SERVICE *No. 1060* BULLETIN

Brake Pedal Binding

SERVICE **No. 1075A** BULLETIN

MODIFICATION OF STEERING HORN

Figure 1
Brake Master Cylinder to Rudder Pedal Attach Pin Installation
(Shown with the spring washer removed)

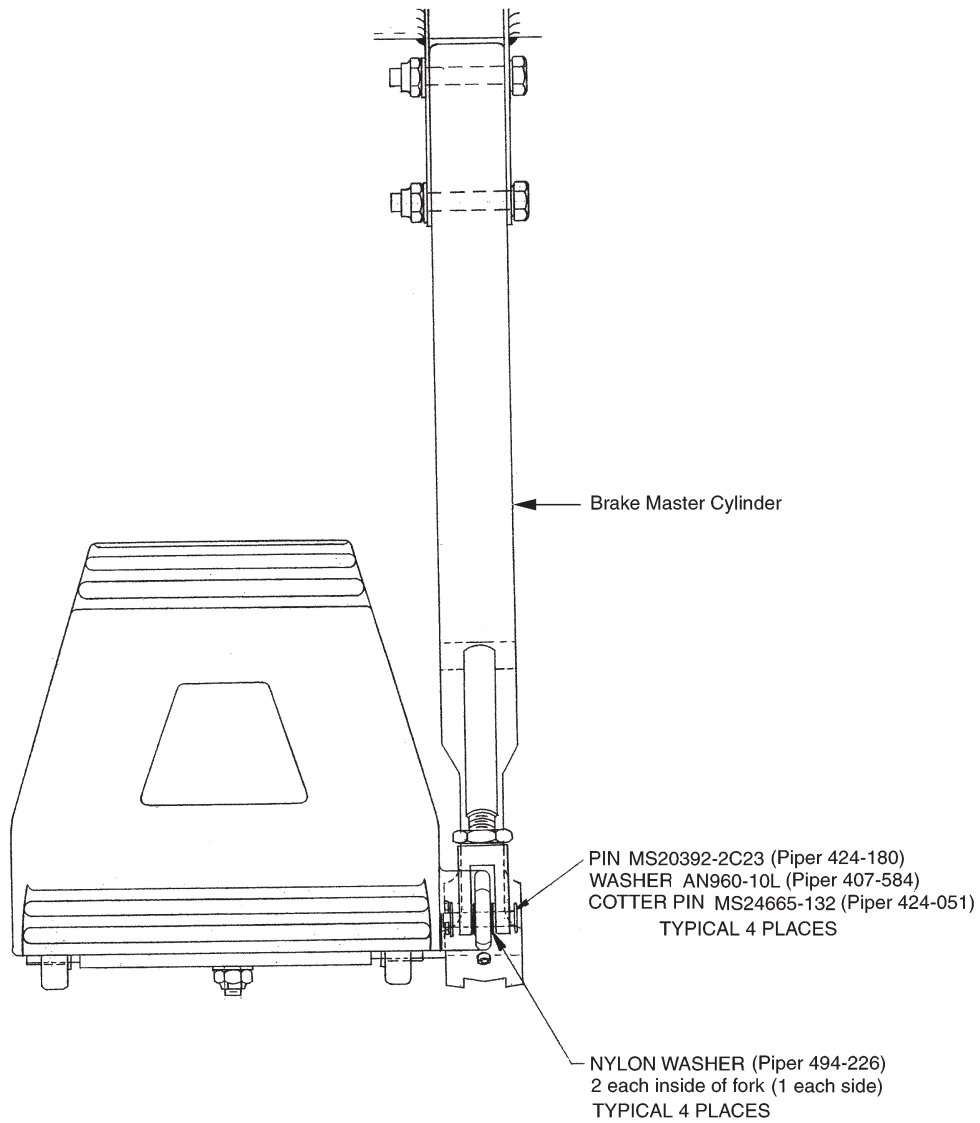
It has been discovered that the pin that attaches the brake master cylinder to the rudder pedals may be restricted in its movement, due to the installation of a spring washer, causing the brake pedals to bind and not fully release pressure to the brake system. This Service Bulletin provides instructions for the removal of the spring washer.

1. Remove the attach pin and related hardware that attaches the brake master cylinder to the rudder pedal (4 locations).
2. Discard the spring washer and inspect the remaining hardware for condition and replace with new, if required.
3. Reinstall the attach pin and hardware without the spring washer.
4. Make a logbook entry indicating compliance with this Service Bulletin.

Figure 1
Steering Horn

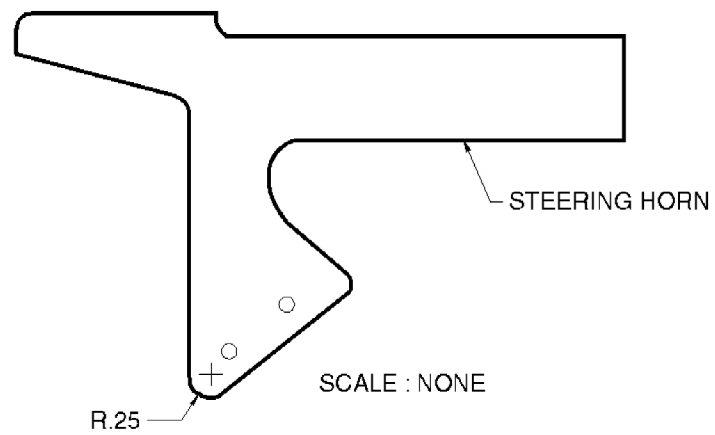
It has been discovered that when the aircraft is being towed (full left turn), the steering horn may contact and damage the engine mount tube located in the vicinity of the Nose Landing Gear (NLG).

1. Jack up the airplane per the Maintenance Manual. Gear is to be clear of the floor.
2. Disconnect both nose gear doors.
3. Retract the landing gear.
4. Trim the steering horn (P/N 85154-002) to incorporate the 0.25 radius as illustrated in Figure 1, (re-identify to P/N 85154-012) or replace the steering horn with a new steering horn, P/N 85154-012.

Figure 1
Engine Mount Inspection Areas

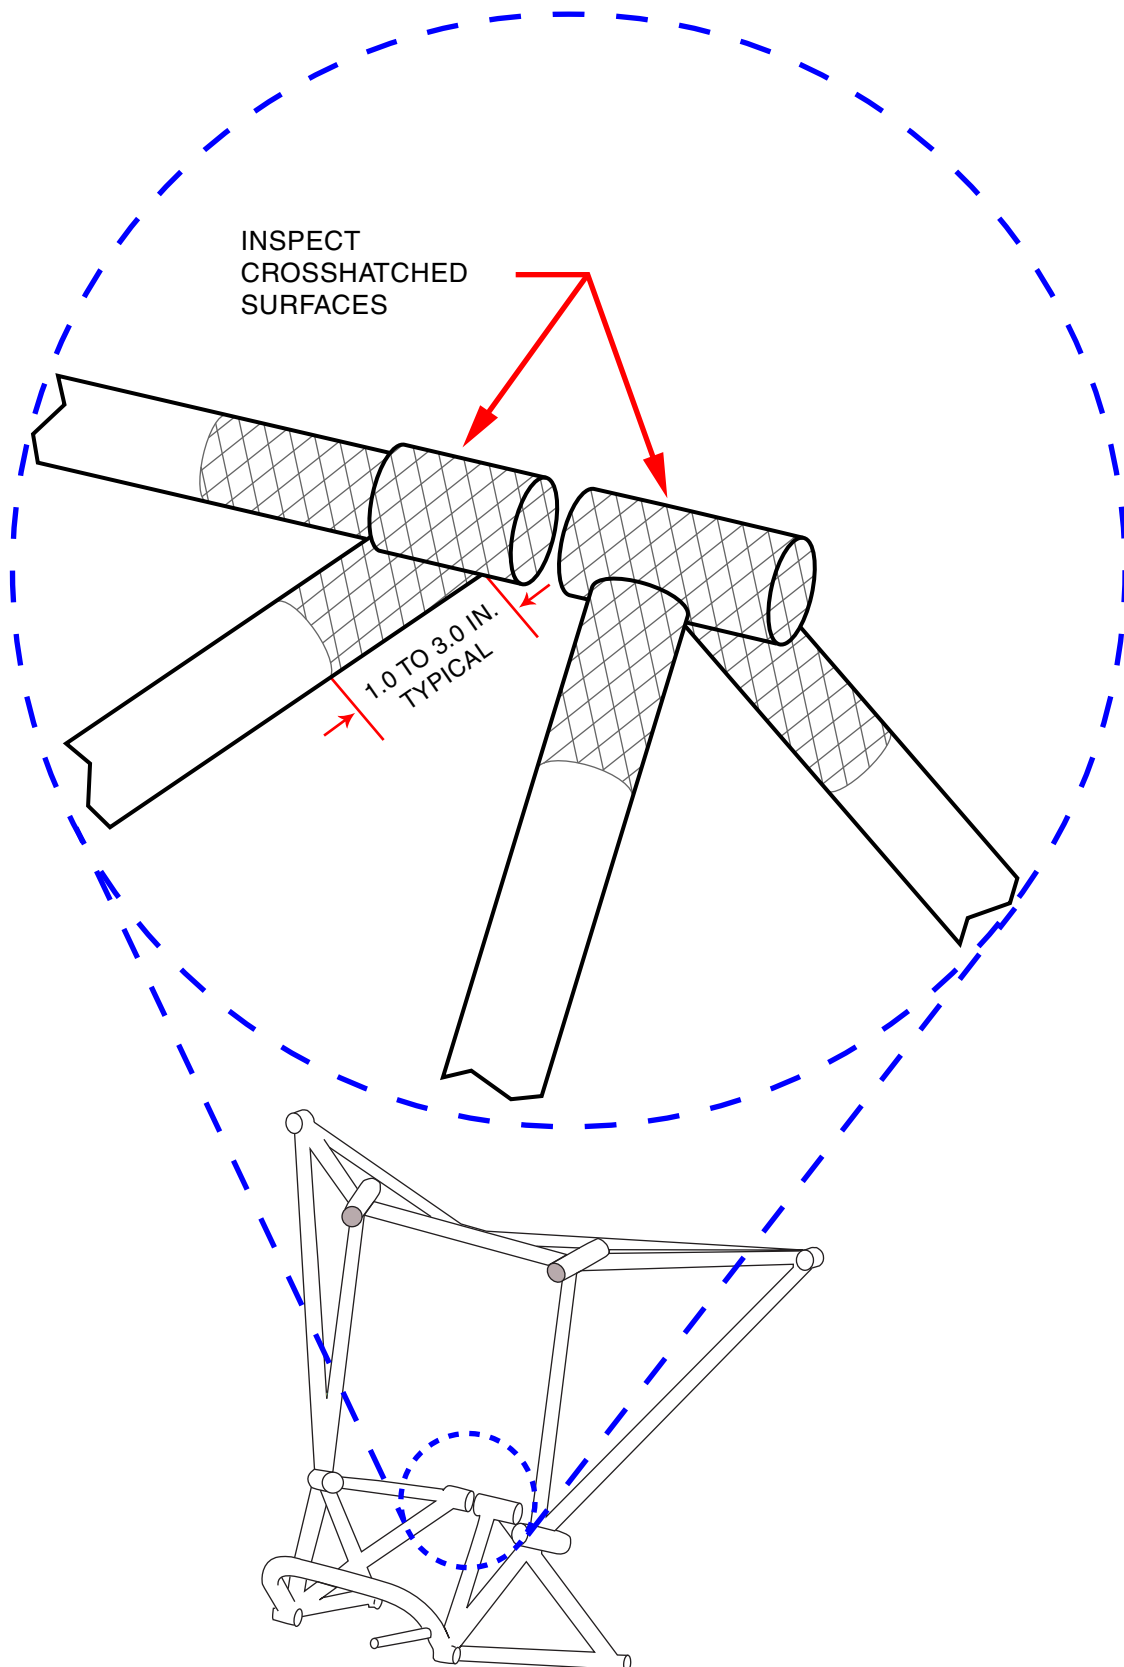
Cracks may develop in the area of the nose gear actuator attach feet on the engine mount (see Figure 1). This condition can occur when the nose landing gear is subjected to excessive loads due to hard landings, rough field operations, excessive speed turns, improper airplane towing (sudden, aggressive starts and stops), or other improper operations.

1. Clean the engine mount actuator attach feet area.
2. Completely remove all of the paint or Dinitrol AV8 and AV30, if the paint was previously removed and covered with Dinitrol AV8 and AV30, from the inspection area (refer to Figure 1).

3. Perform fluorescent penetrant inspection of the nose gear actuator attach feet for cracks per AC 43.13-1B, Chapter 5, Section 5. Inspect the surfaces identified in Figure 1, with specific emphasis on welded areas.
4. If a crack is discovered, the engine mount must be replaced prior to further flight (refer to Table 1).
5. If no cracks are found, continue the repetitive inspection per the compliance time above.
6. Clean the feet and apply a two-coat corrosion prevention compound (CPC) to the area where the paint was removed. This two-coat CPC consists of Dinitrol/Ardrox AV8 as a primer coating and (after the AV8 has dried) Dinitrol/Ardrox AV30 as a top coating.
7. Make an appropriate logbook entry of compliance with this service bulletin for each repetitive inspection.

**Figure 2**

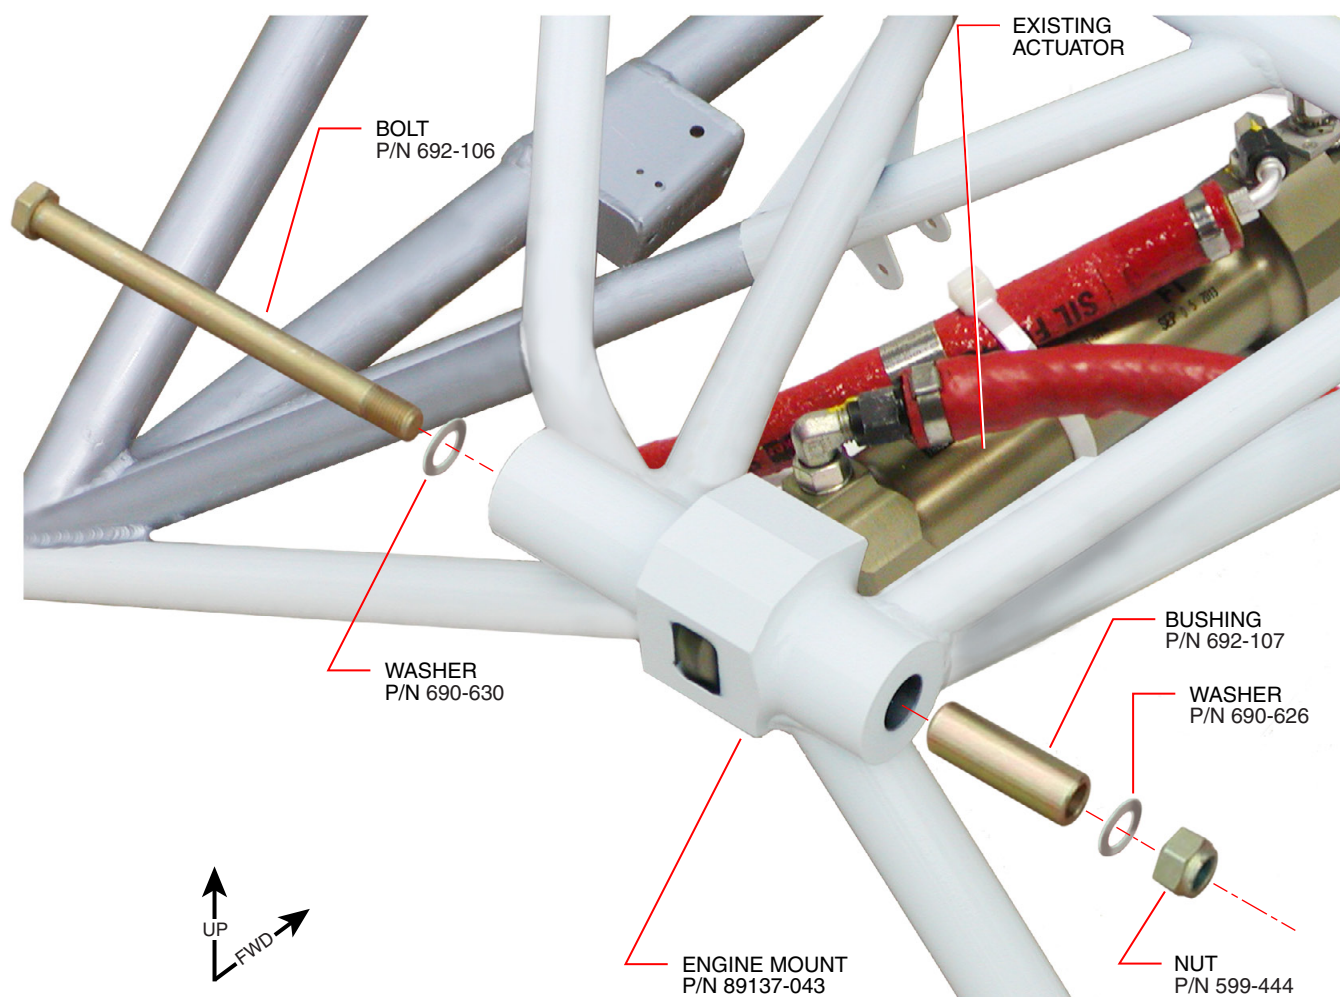
NOTE: For PA-46-350P Mirage and PA-46R-350T Matrix models only, Piper has developed a corrective action to eliminate the recurring inspection requirement, whether or not a crack has been discovered. If the engine mount on an affected PA-46-350P or PA-46R-350T model is replaced with P/N 89137-043 (Part II), the repetitive inspection requirement is eliminated.

1. If cracks are found on the engine mount, order the appropriate replacement engine mount found in Table 1, and hardware, as required.
2. Install the new engine mount according to procedures in the applicable Piper airplane maintenance manual. For PA-46-350P Mirage or PA-46R-350T Matrix model airplanes only: fasten the aft end of the nose gear actuator to the engine mount using the hardware arrangement shown in Figure 2. Torque nut according to requirements in section 91-10-00 of the applicable Piper airplane maintenance manual. At all other locations, hardware in serviceable condition may be reused.

Proper orientation of hardware shown
Figure 1

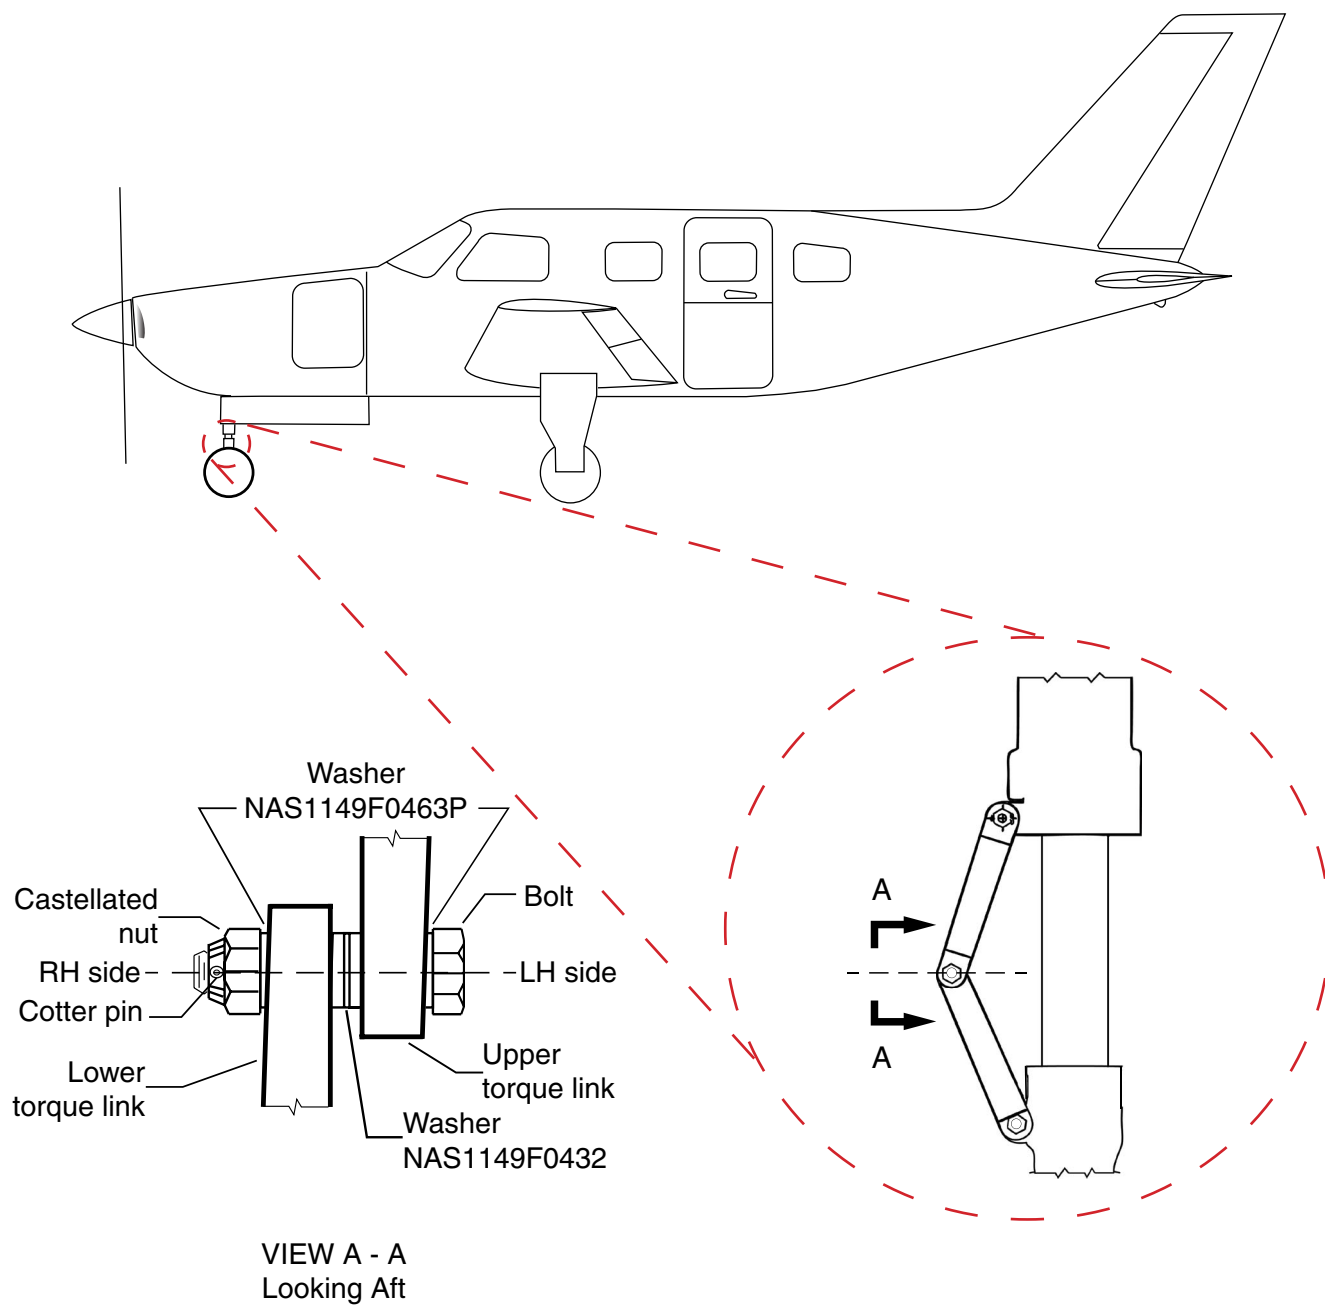
Under certain conditions, use of tow straps may cause the loss of this cotter pin, which is the only means of preventing loss of the free running castellated nut and the torque link connecting bolt.

This Service Bulletin provides instructions for replacing the factory-installed free running castellated nut with a new castellated nut that includes a self locking feature, which provides a secondary locking mechanism. Additionally, the orientation of the bolt is specified.

1. Order replacement hardware as shown in TABLE 1.
2. Locate the torque link connecting bolt and associated hardware, as shown in Figure 1.
3. Remove and discard the existing cotter pin and castellated nut.
4. If necessary, remove torque link connecting bolt and reinstall to orient bolt head on left hand side of aircraft, as shown in Figure 1.
5. Install new self locking Castellated Nut (MS14144-4), Piper P/N 603-816 onto existing torque link connecting bolt, as described in the applicable maintenance manual. Tighten castellated nut only tight enough to allow no side play in the upper and lower torque links, yet still be loose enough to allow the torque link connecting bolt to freely rotate.
6. Secure castellated nut with new Cotter Pin (MS24665-132), Piper P/N 424-051.
